INDIANA DEPARTMENT OF ENVIRONMENTAL MANAGEMENT

Re: NPDES Permit No. IN0063711
ArcelorMittal Indiana Harbor, LLC –
Central Wastewater Treatment Plant
East Chicago, Indiana
Lake County

A response to the comments received pertaining to the draft NPDES permit is contained in the Post Public Notice Addendum. The Post Public Notice Addendum is located at the end of the Fact Sheet.

National Pollutant Discharge Elimination System
FACT SHEET
for
ArcelorMittal Indiana Harbor, LLC – Central Wastewater Treatment Plant
October 2011

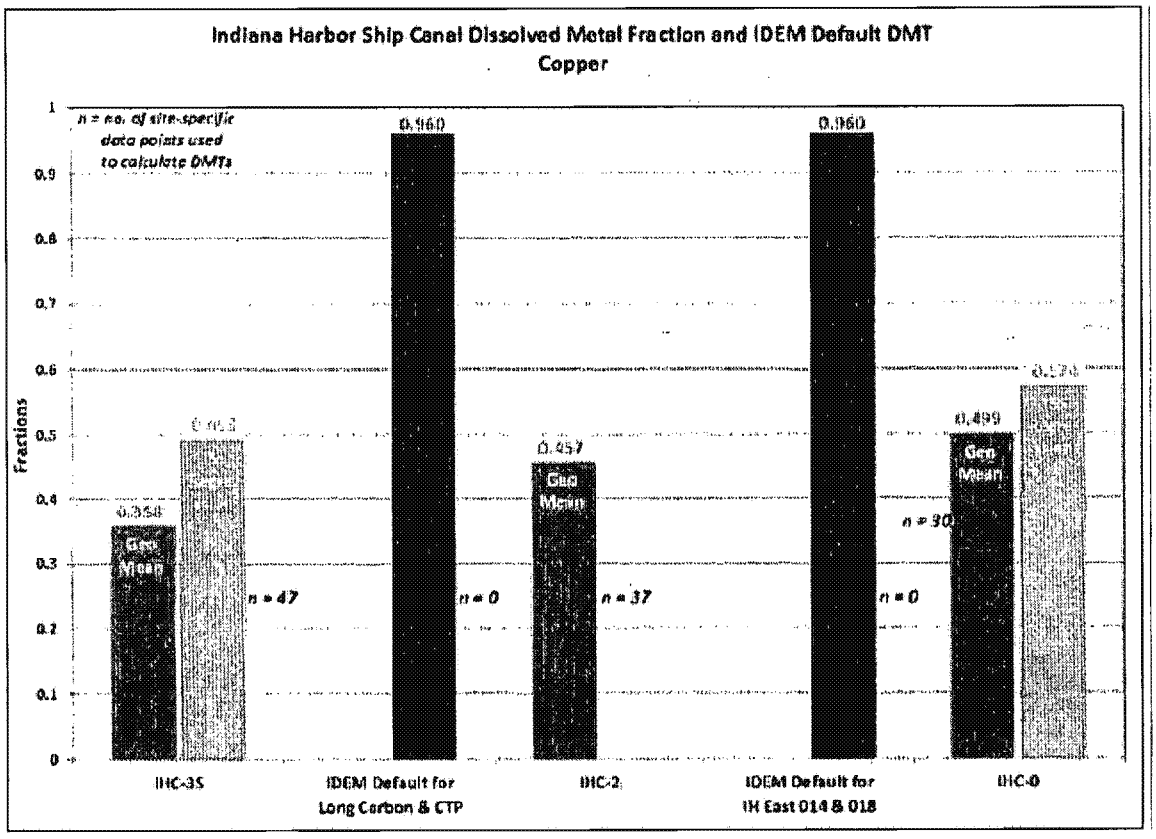
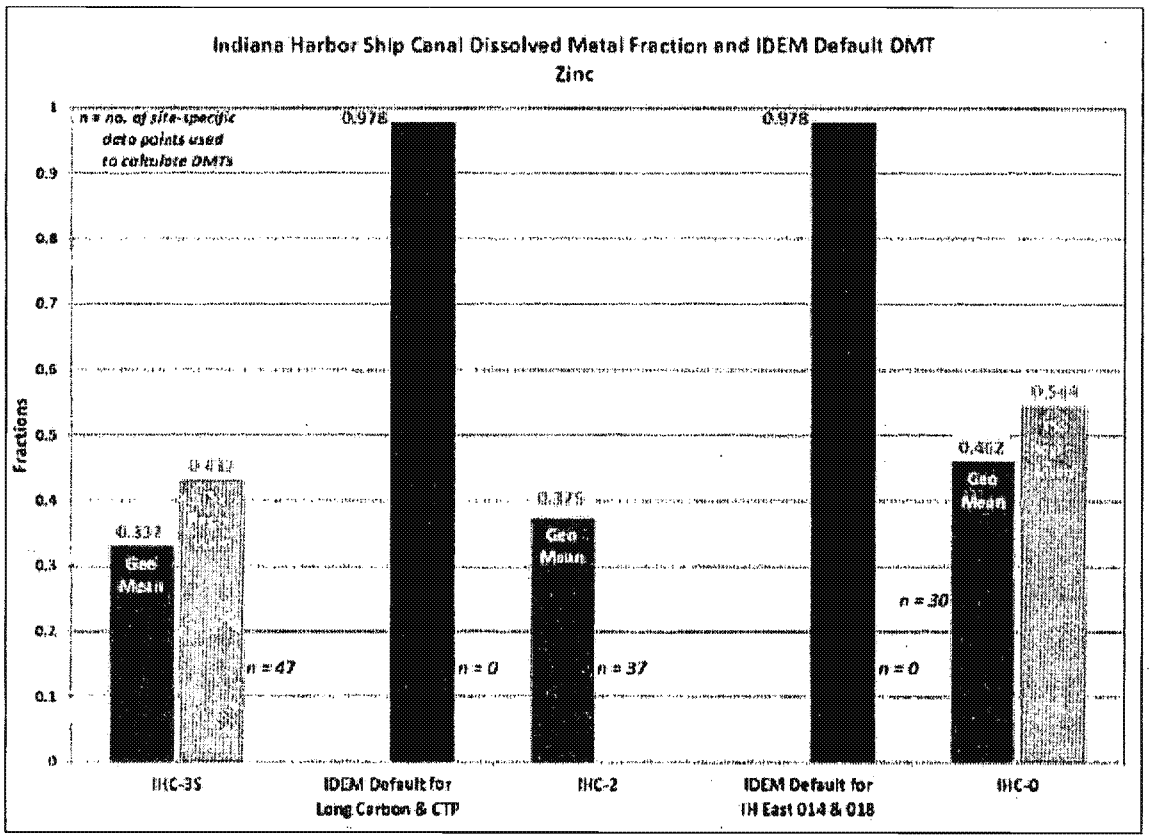
IDEM's default DMTs, which rely on no data specific to the IHSC, are clearly inaccurate for the ArcelorMittal permits and overestimate the dissolved copper, lead and zinc fractions in the IHSC by significant amounts. For example, the default translators are 2.1, 3.0 and 2.6 times greater than the calculated geometric mean of the dissolved fractions for copper, lead and zinc, respectively, at IHC-2. Even the 95th percentiles of the dissolved fractions for all metals at all locations are significantly below IDEM's default translators. As shown, the DMTs calculated at IHC-3S, IHC-2 and IHC-0 are considerably lower than IDEM's default DMTs used in the calculation of WQBELs. Graphs of the geometric mean dissolved fractions, TSS-regression developed DMTs, and IDEMs default DMTs are presented below.

Given the data presented in the table and graphs above, it is not reasonable to assume, as IDEM has done through use of the default DMTs, that the dissolved metal fraction in the water column somehow increases dramatically in between the fixed monitoring stations. ArcelorMittal's requested effluent limits, based upon site-specific DMTs derived from the IDEM fixed monitoring station data and other factors, are presented below.

FIGURE 1

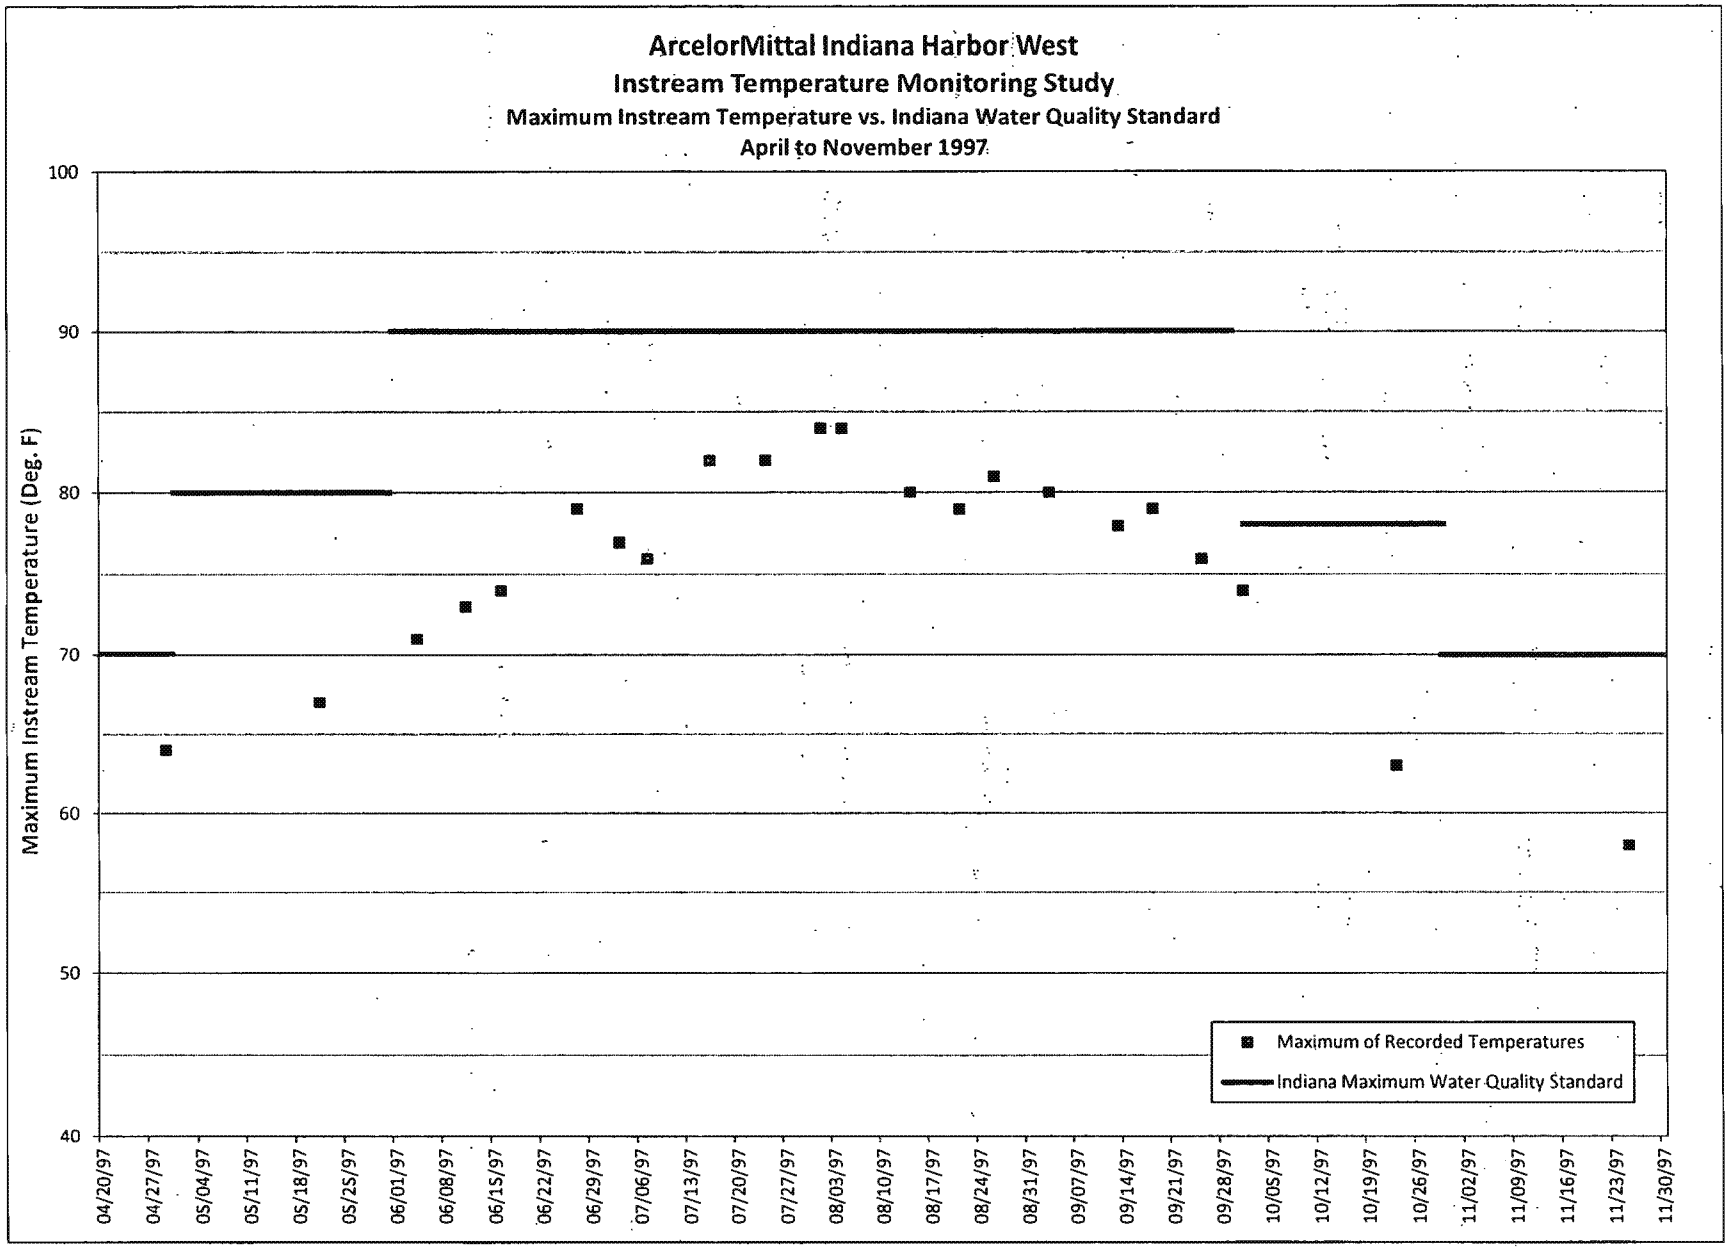
The in-stream temperature monitoring data show maximum temperature water quality standards were met at all locations monitored in 1997 and 1998. The results are shown graphically in Figures 1 and 2.

FIGURE 3

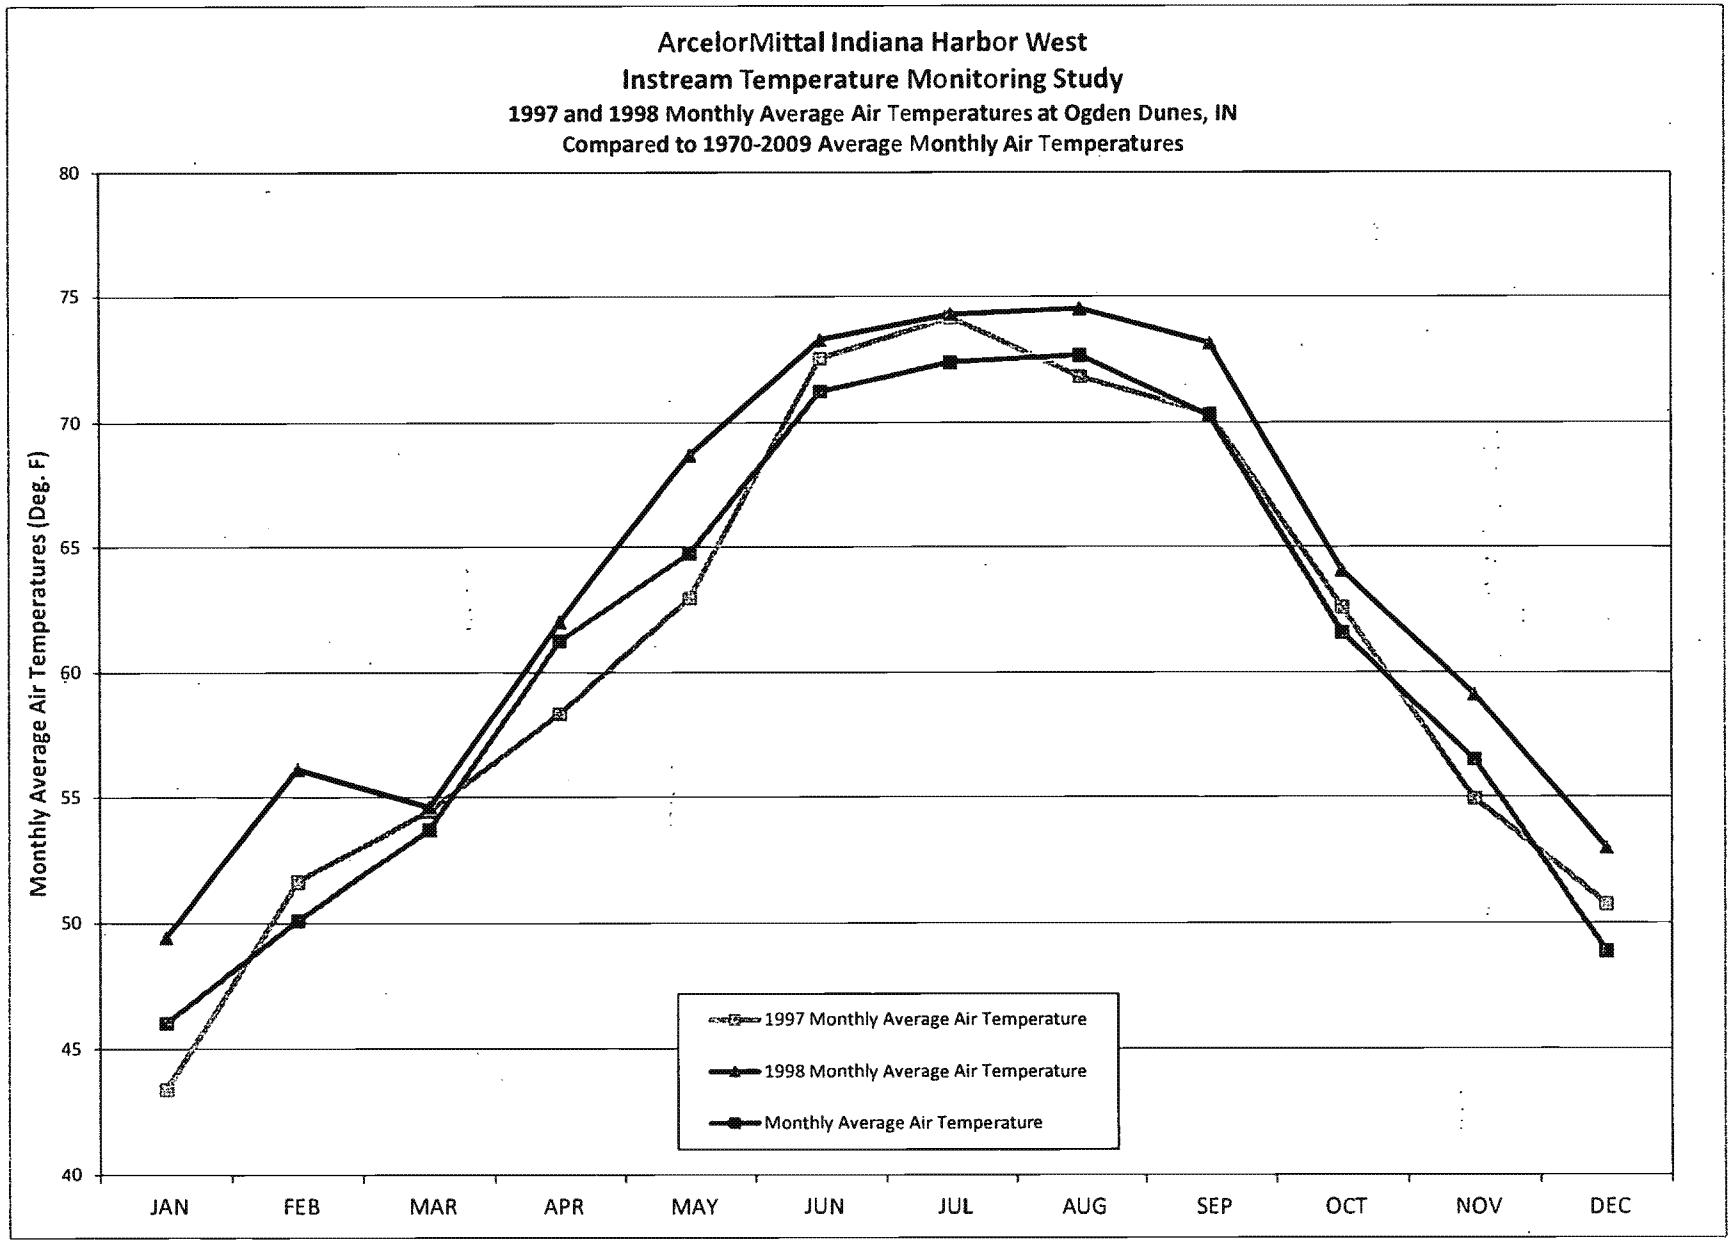
These data show ambient air temperatures in 1997 and 1998 were typical of historic conditions and suggest in-stream temperatures for 1997 and 1998 are representative of thermal discharges at the time and typical summer air temperatures. Monthly average data for January through December are included as Exhibit C and are shown graphically in Figure 3.

FIGURE IHW-1

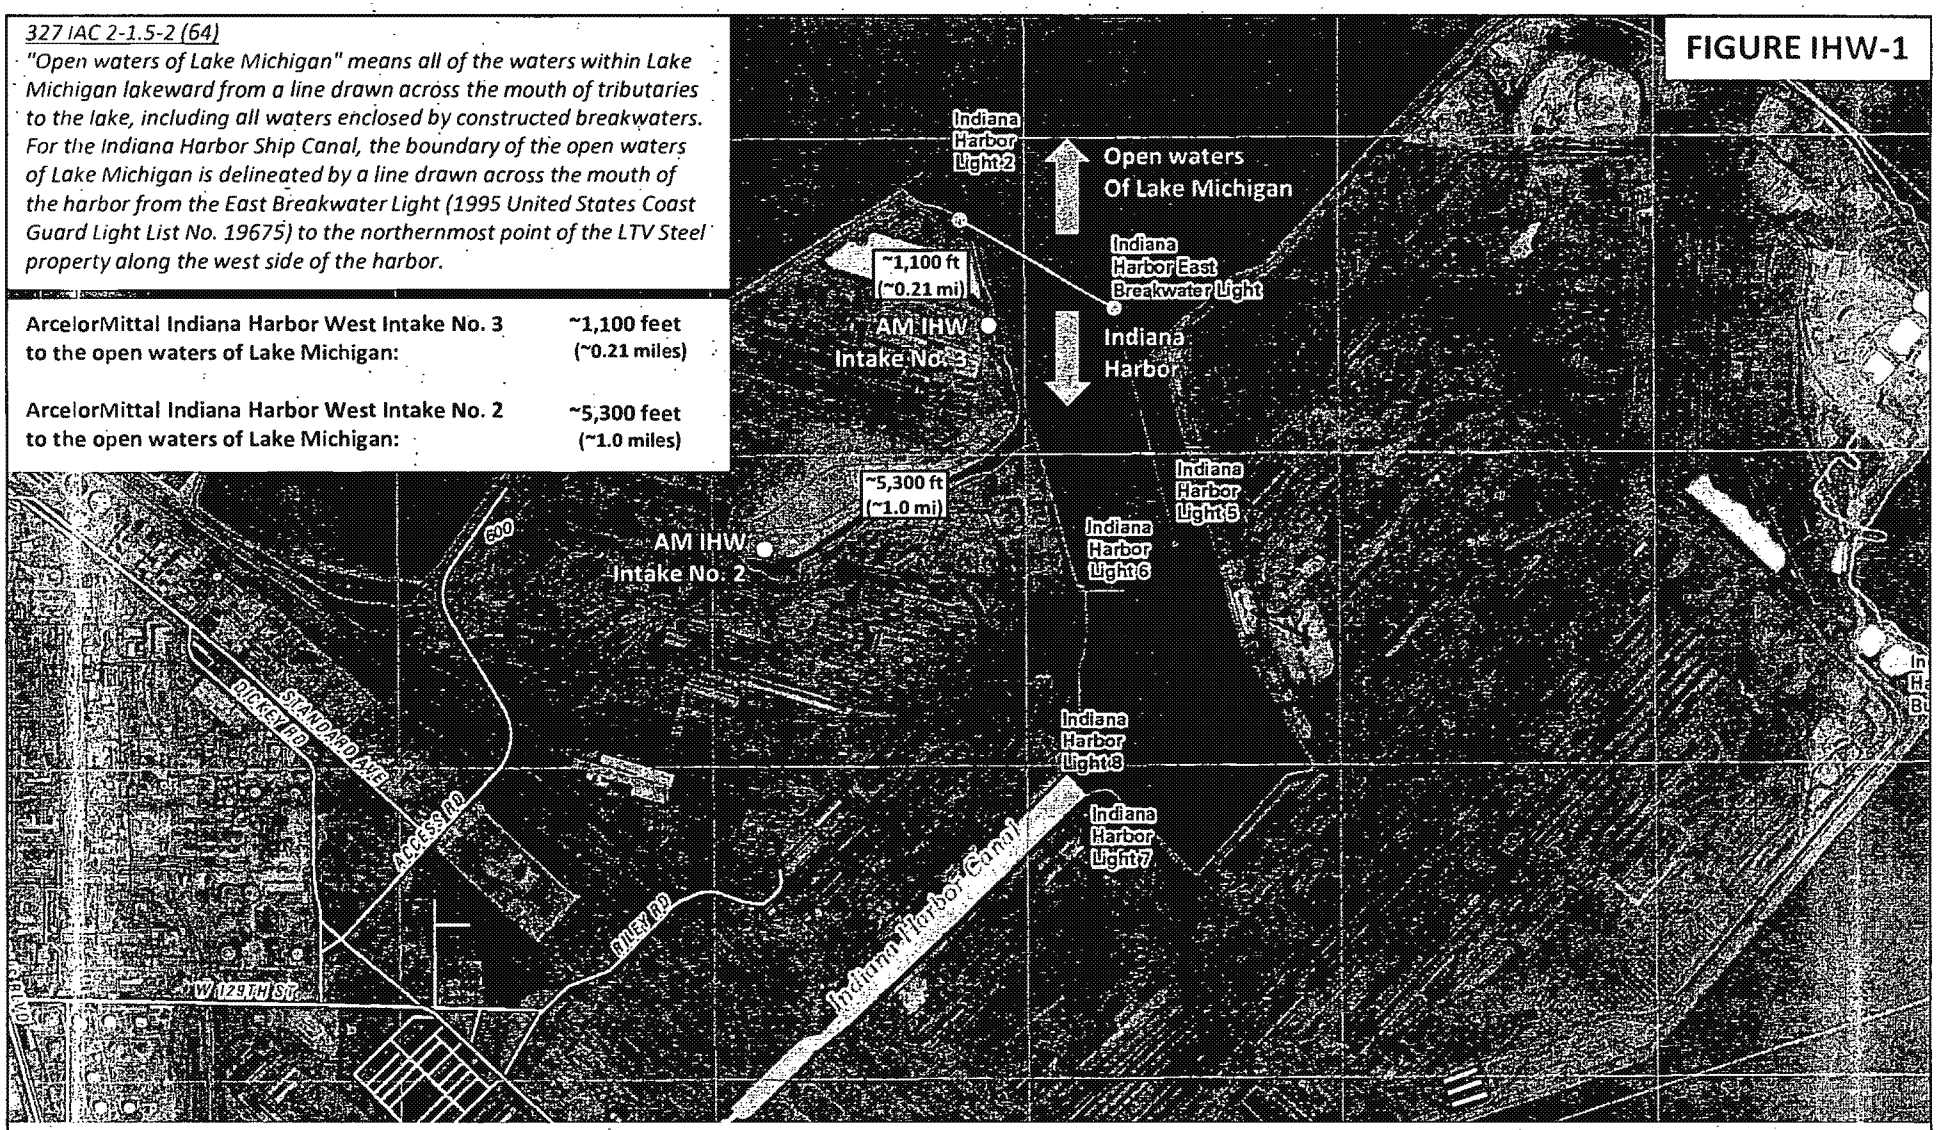
IDEM states in Attachment A of the Fact Sheet (p. 5), that Indiana Harbor West has two water intakes in Lake Michigan; and, that IDEM considers the intake channel for the Nos. 2 and 3 intakes as "open waters of Lake Michigan" (p. 12). Figure IHW-1 is an aerial photograph showing the Nos. 2 and 3 intakes, the intake channel and the northern section of the Indiana Harbor Ship canal that borders the open waters of Lake Michigan. A line depicting the boundary described in the above definition of "open waters of Lake Michigan" is shown on the aerial photograph. It is evident from a simple reading of the regulatory definition of "open waters of Lake Michigan" and review of the aerial photograph that the Indiana Harbor West intake channel and the Nos. 2 and 3 intakes are not within open waters of Lake Michigan. They are not lakeward of the line between the East Breakwater Light and the northernmost point of LTV Steel property (now ArcelorMittal Indiana Harbor LLC property). In fact, the No. 3 Intake is approximately 0.21 miles south of the northernmost point of ArcelorMittal property and the No. 2 intake is approximately 1.0 miles south and southwest of the northernmost point of ArcelorMittal property. Thus, IDEM's assertion that the intake channel for the Nos. 2 and 3 intakes are within the

ArcelorMittal Indiana Harbor West Intake No. 3 to the open waters of Lake Michigan:	**~1,100 feet (~0.21 miles)**
ArcelorMittal Indiana Harbor West Intake No. 2 to the open waters of Lake Michigan:	**~5,300 feet (~1.0 miles)**
